Subject: MHI's Amended Responses to US-APWR DCD RAI No.766-5819
(03.07.02) and 767-5821(SRP 03.08.04)

Amended Responses to Request for Additional Information
No. 766-5819 Revision 3

**US-APWR Design Certification
Mitsubishi Heavy Industries
Docket No. 52-021**

Amended Responses to Request for Additional Information
No. 767-5821 Revision 3

WATERSTOP DETAIL

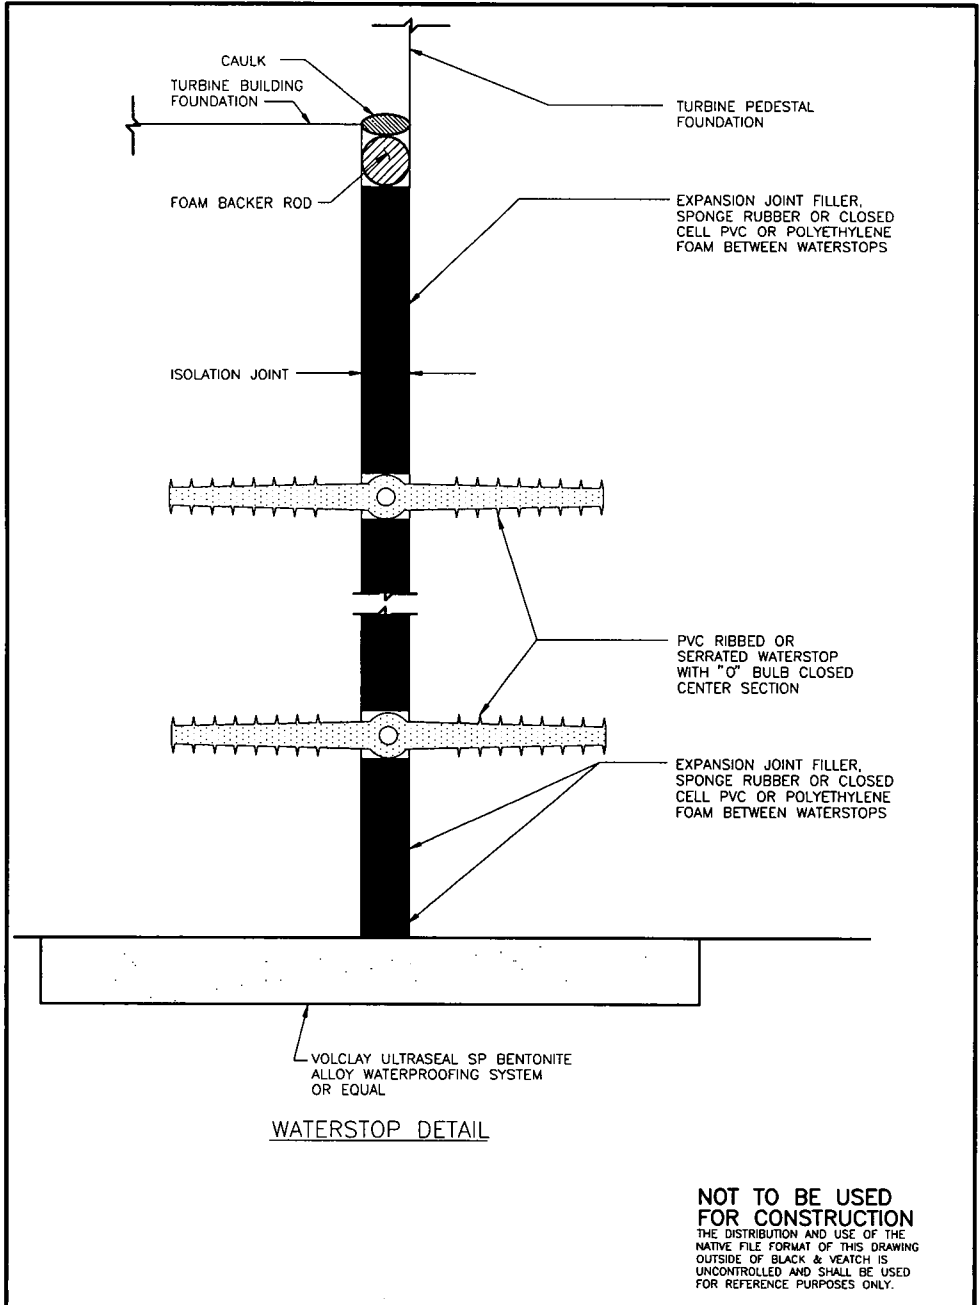
The staff noted that while the mass of the turbine pedestal was considered in the analysis, the potential effects of this pedestal on SSI results or on any interaction between it and the T/B foundation is not specifically addressed. No numerical data is included in the report that supports this exclusion of the pedestal. The applicant is requested to describe in detail the design of the joint between the turbine pedestal and the T/B foundation and explain why the effects (other than consideration of the mass) of the pedestal on SSI or other aspects of the analysis are not important, and that by ignoring these effects results in a conservative analysis. Additionally, the applicant should confirm that the weight of the turbine generator is included in the analysis.

The seismic isolation space between the turbine pedestal basemat and the T/B basemat was modeled as 1 inch. The joint between the turbine pedestal and T/B foundation is shown in the attached sketch, Figure 1.

The seismic isolation space between the turbine pedestal basemat and the T/B foundation has 2 elastomeric water stops installed at 2 different elevations to provide a barrier so that ground water does not seep into the T/B basement. Per the manufacturer's data this joint can move up to 6 inches without failure.

Figure 1. Plan Arrangement of Turbine Island and Adjacent Reactor Building and Power Source Buildings

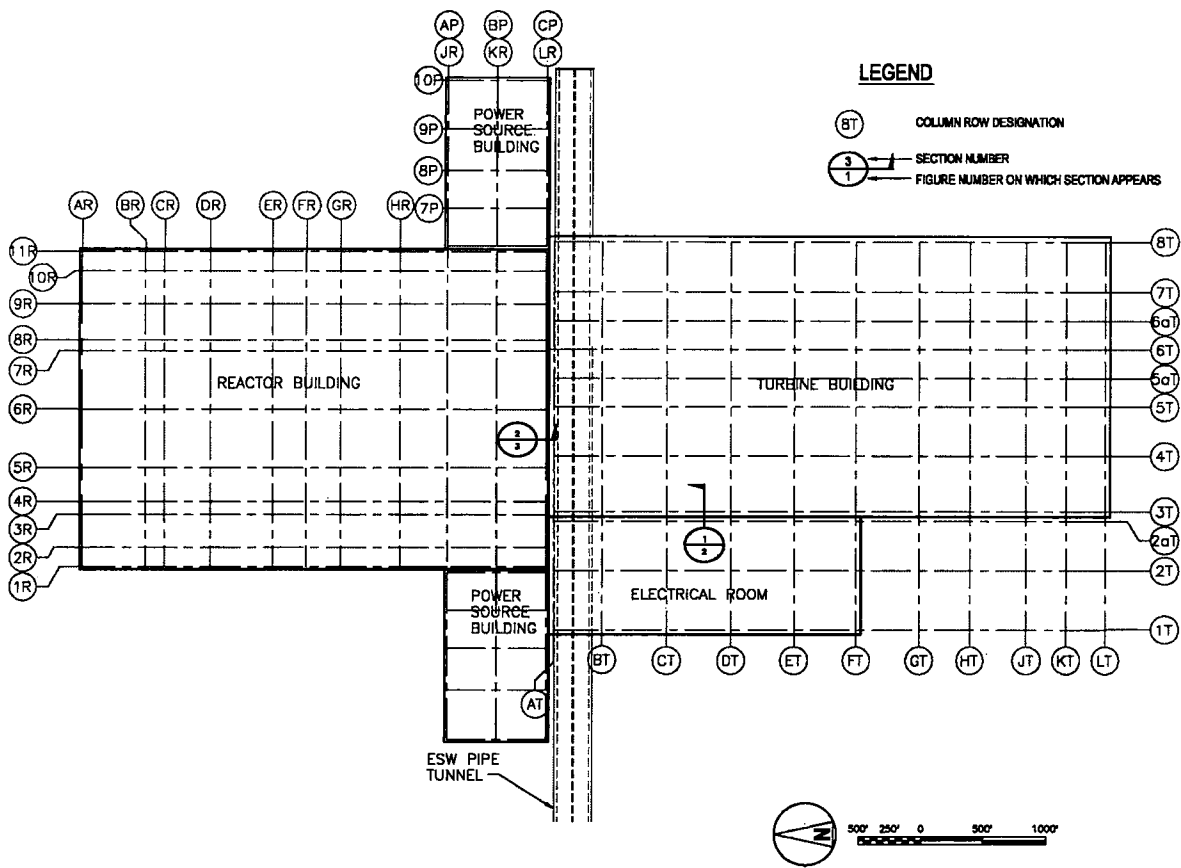
In MUAP-11002 (R0) Subsection 7.1.2, "Results of Maximum Relative Displacements," the applicant identified nodes at which maximum relative displacements are determined. Based on the information provided in the report, the staff was not able to determine whether the applicant considered all appropriate critical locations for computing building clearances for relative displacement. The applicant is requested to provide additional information such as appropriate layout drawings showing relative positions of the T/B and Electrical Room, the R/B, the PS/B, and the potential contact points between the structures.

The attached Figure 1 shows the positions of the Reactor Building, Power Source Buildings, Turbine Building and Electrical Room. The attached Figure 2 shows the elevation view of the interface between the Turbine Building and the Electrical Room, and the attached Figure 3 shows the elevation view of the interface between the Turbine Island and the Reactor Building and Power Source Buildings. These figures are included in MUAP-11002 (R1). The minimum gap distance shown in Figures 2 and 3 is 1 foot 4 inches.

Figure 1. Cross Section Through Turbine Building and Electrical Room

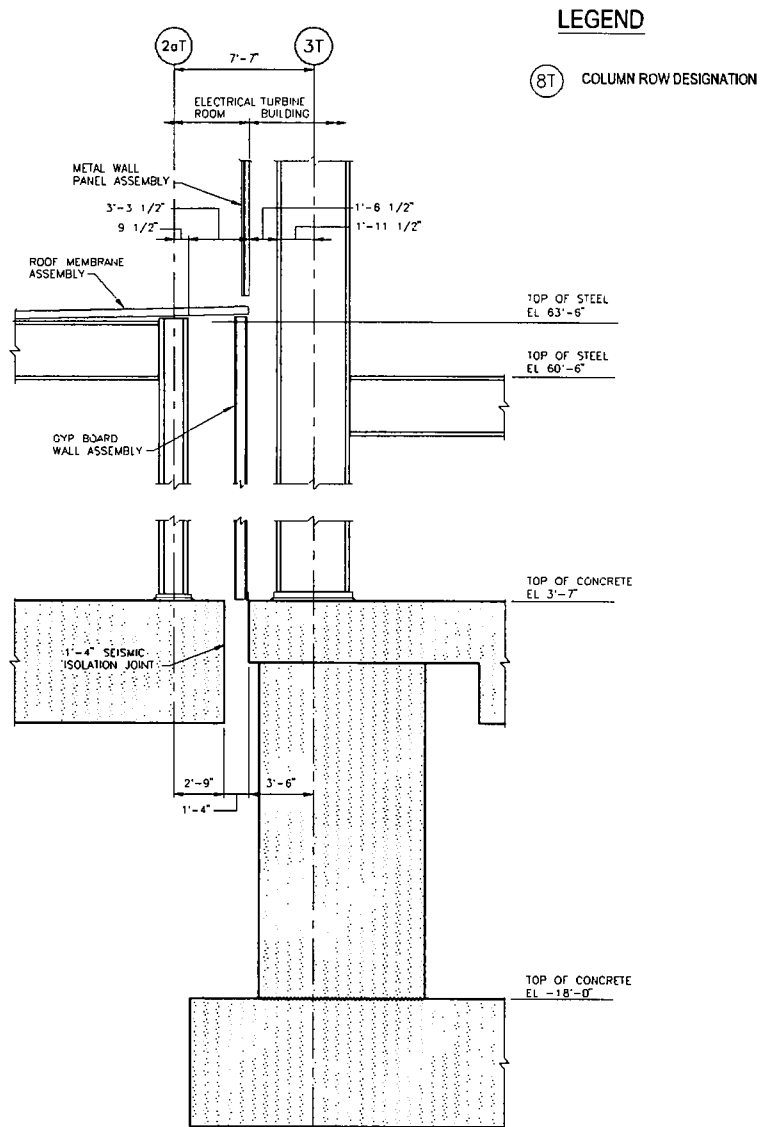
In MUAP-11002 (R0) Subsection 4.2, "Electrical Room," the last sentence in the first paragraph (page 12) states, "The Electrical Room is also structurally separated from the T/B." The applicant is requested to define the meaning of "structurally separated." If there is an engineered clearance between the structures and foundations, the Applicant should demonstrate that the clearance is sufficient to prevent contact between the structures and foundations during a seismic event. If there is not an engineered clearance, the applicant should explain why a clearance is not required to prevent contact between the structures and foundations of the Electrical Room and T/B during a seismic event.

The meaning of "structurally separated" is the Turbine Building and Electrical Room are physically separate and distinct structures with an engineered clearance between the superstructures and foundations. A clearance of 4 feet 10 inches is provided between the two steel superstructures to prevent contact during a seismic event.

At the foundation level, a clearance of 1 foot 4 inches is provided between the Turbine Building and Electrical Room foundations for seismic separation and constructability. The Turbine Building and Electrical Room superstructure and foundation clearances are reevaluated in MUAP-11002 (R1) using the SSI analysis results. The attached Figure 1 shows the elevation view of the interface between the Turbine Building and the Electrical Room looking north along column lines 2aT and 3T. This Figure is identical to Figure 2 shown in the answer to RAI 03.07.02-52.
